S-0031-2017,234 Neck O'Land Subdivision

Re: Minor Subdivision of 234 Neck-O-Land Road (Development Plans)

James City County plan S-0031-2017

STORMWATER & RESOURCE PROTECTION DIVISION REVIEW COMMENTS 234 Neck O'Land Subdivision COUNTY PLAN NO. S-031-17

01 of 12

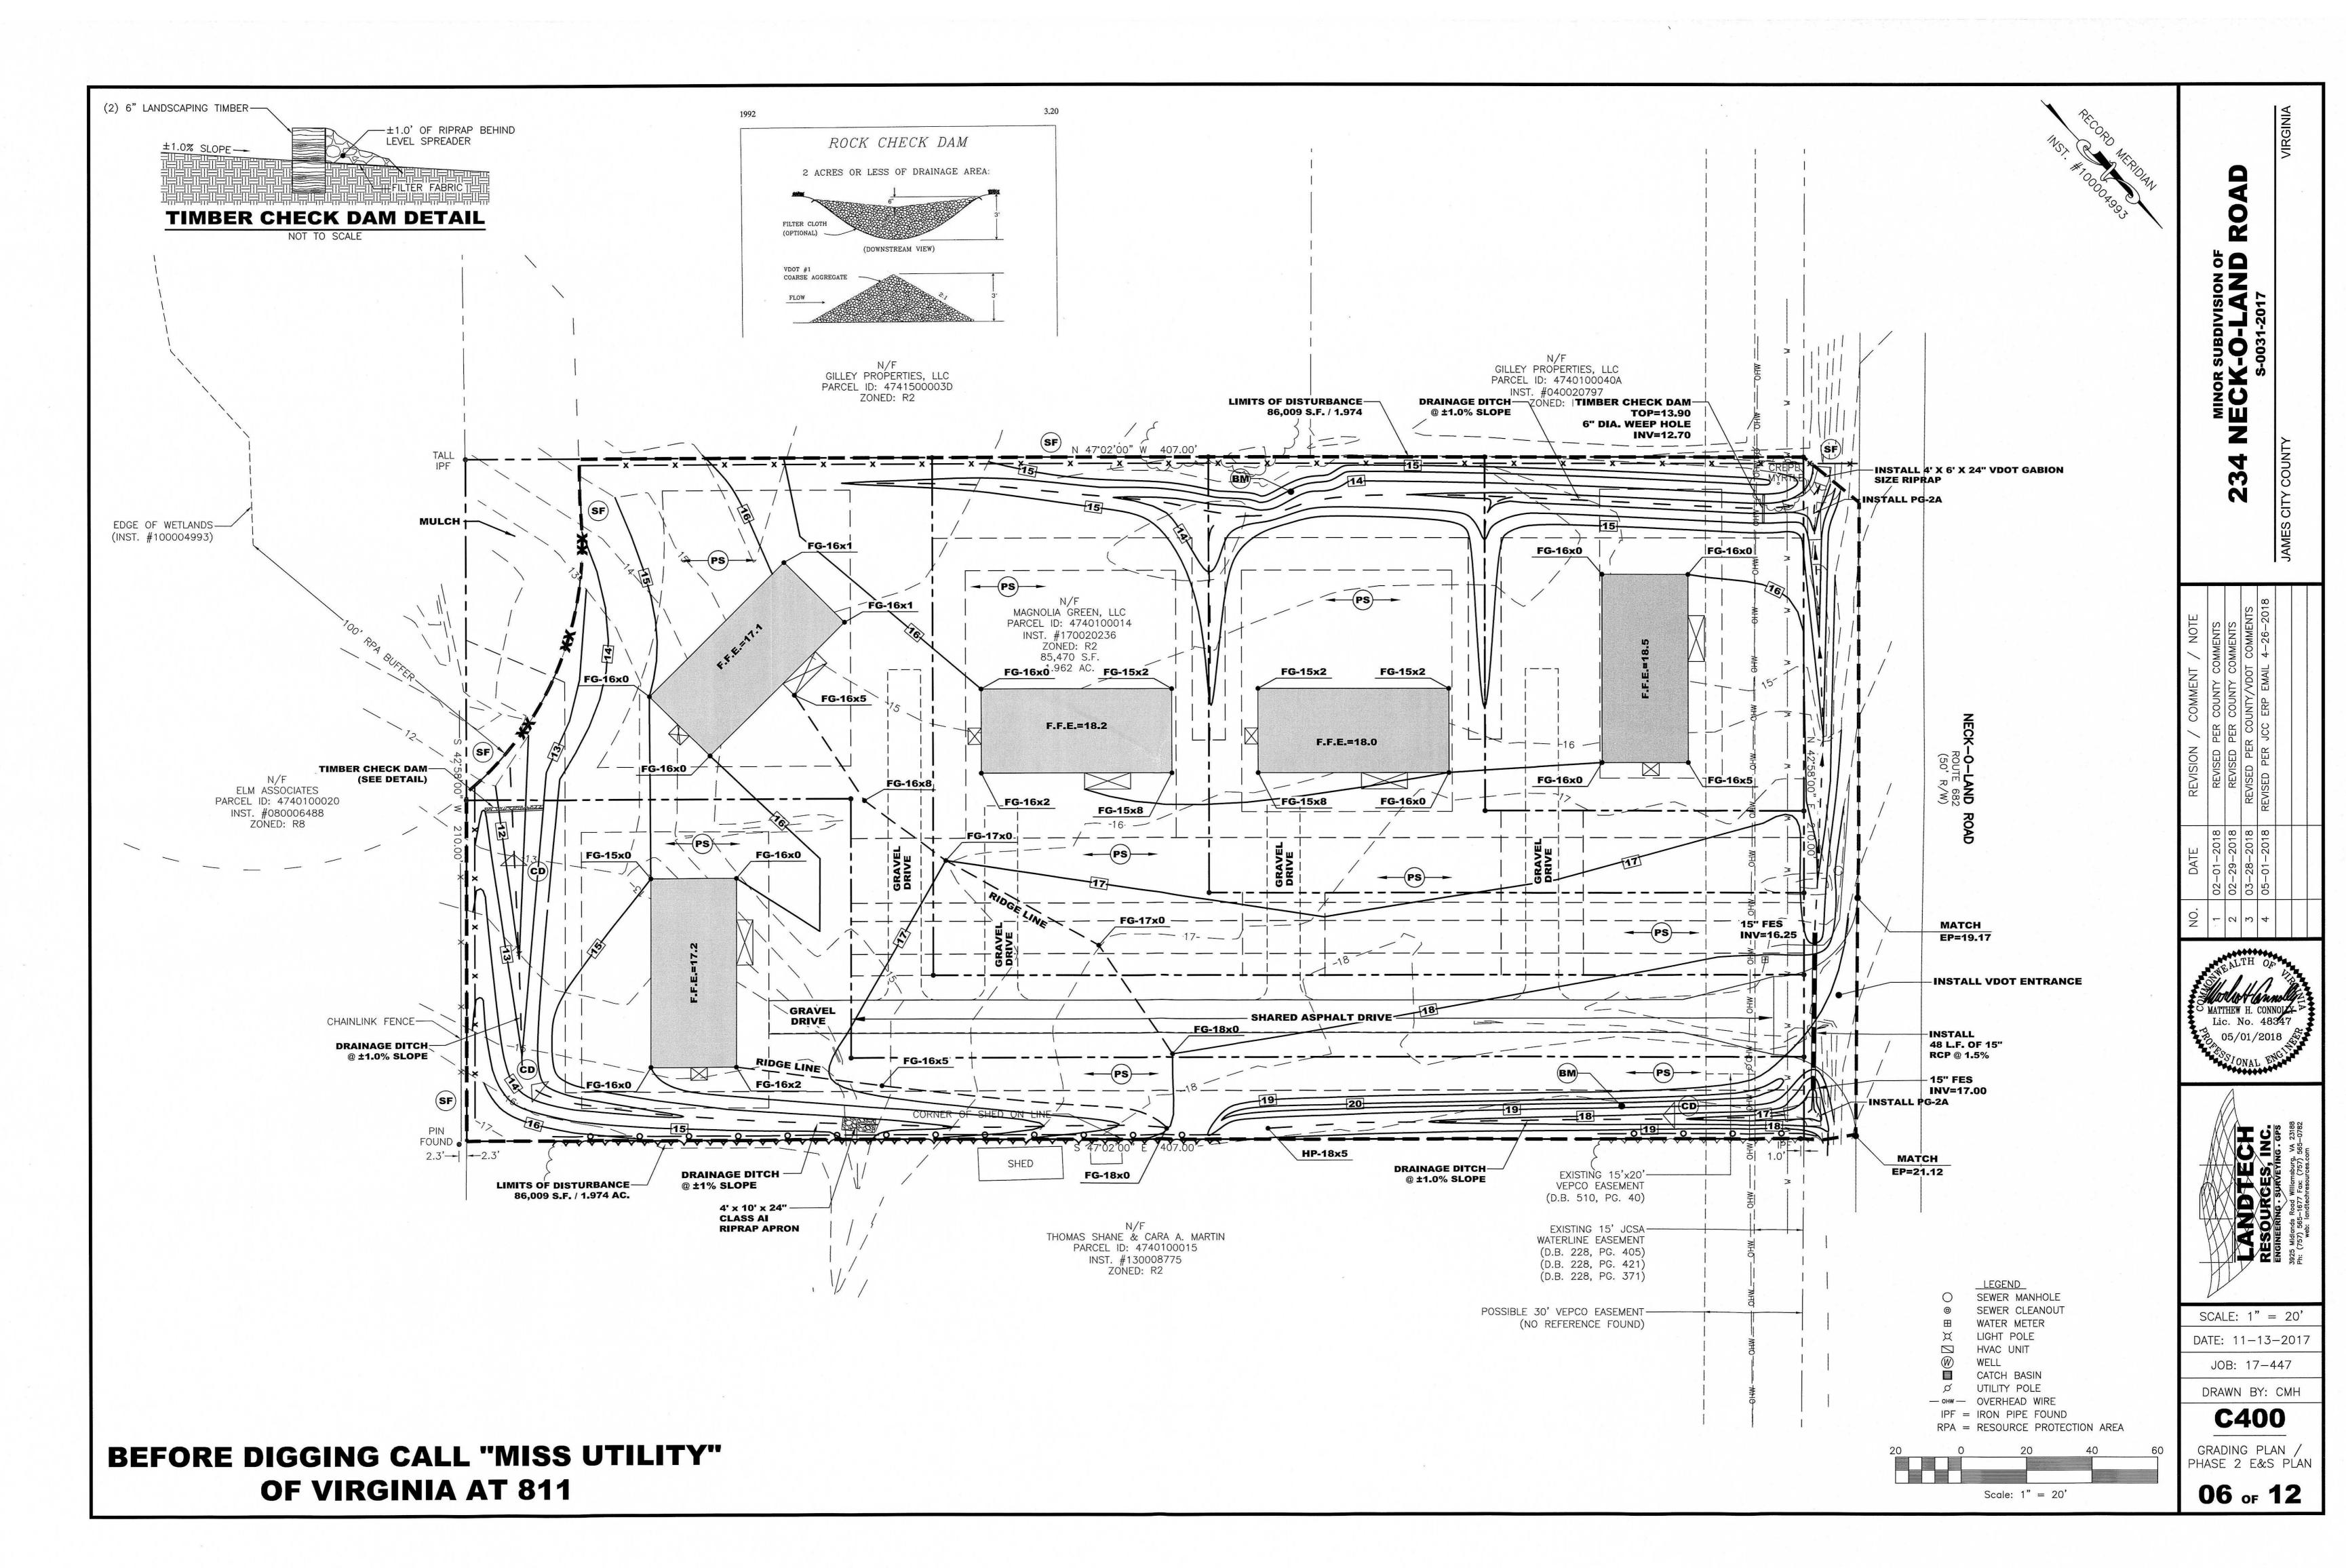
- 1. Sediment Trap. The proposed sediment trap needs to be installed at the Phase I as part of the preliminary E&S Control measures. Review.
- 2. Proposed Ditches. The proposed ditches not in connection with the sediment trap should have a riprap and stone barrier similar to the one in the trap spillway to control sediment laden from leaving the site. Consider isolating the ditch that runs toward the RPA entirely, since offsite runoff will be also added to it.

- 5. Proposed Ditches. The temporary check dams shown on sheet C400 should be installed on the Phase I of the Erosion and Sediment Control plan. Ensure this is included on the construction sequence as well. Please review.

1. A sediment trap has been added to C201

- 2. Swales have been relocated to run along the property lines. Easements have been added over top of drainage swales.
- 3. The level spreader is not designed in accordance with VA DEQ Stormwater Design Spec #2. The intent is just to spread out concentrated flows.
- 4. This area has been revised.
- 5. An easement have been provided on the diversion swales along the edge of the property to benefit the northern parcels.
- 6. Two (2) sets of calculations have been included with this submission showing compliance.
- 7. Water Quantity Drainage Maps with appropriate calculations have been provided at the end of the plan set.
- 8. Sections of the open channels have been provided on DA101

SHARED PRIVATE ROAD PAVEMENT SECTION

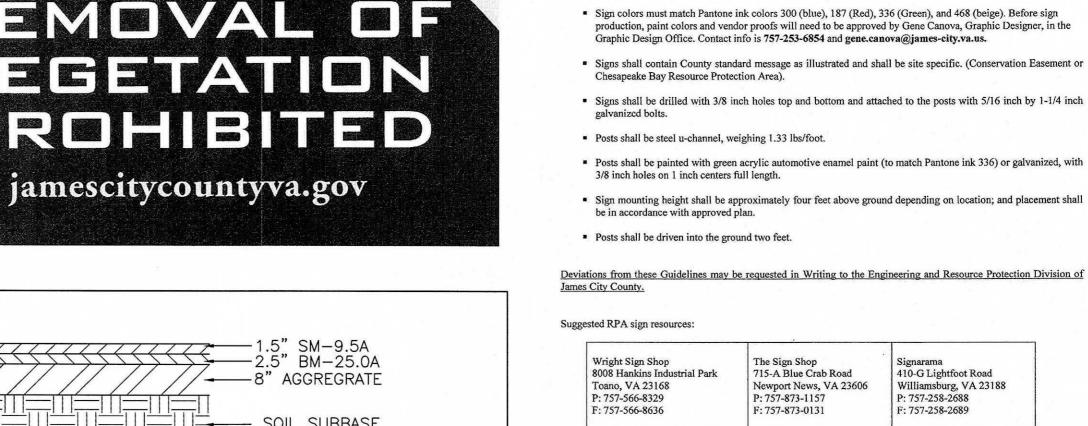
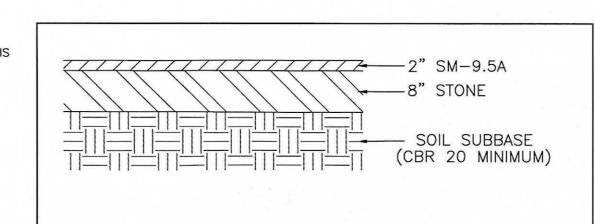
SRP: they plan to improve longer, existing driveway as shared. Please comment re: any requirements for showing on plan/bonding etc

A construction detail for the Shared Driveway has also been added to Sheet 2. Per VDOT request: the detail for the low volume commercial entrance has been added to Sheet 2

FIGURE 4-8 COMMERCIAL ENTRANCE DESIGN TO SERVE A PRIVATE SUBDIVISION ROAD / STREET

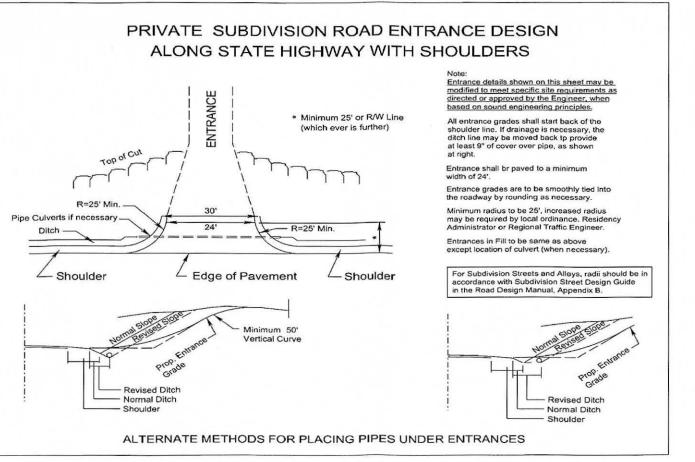
- 1) A combined entrance will require low volume commercial standards.
- 2) Stopping sight distance needs to be demonstrated to be adequate at the proposed entrance. Please show sight distances and any necessary easements or clearing on the plat or an exhibit.
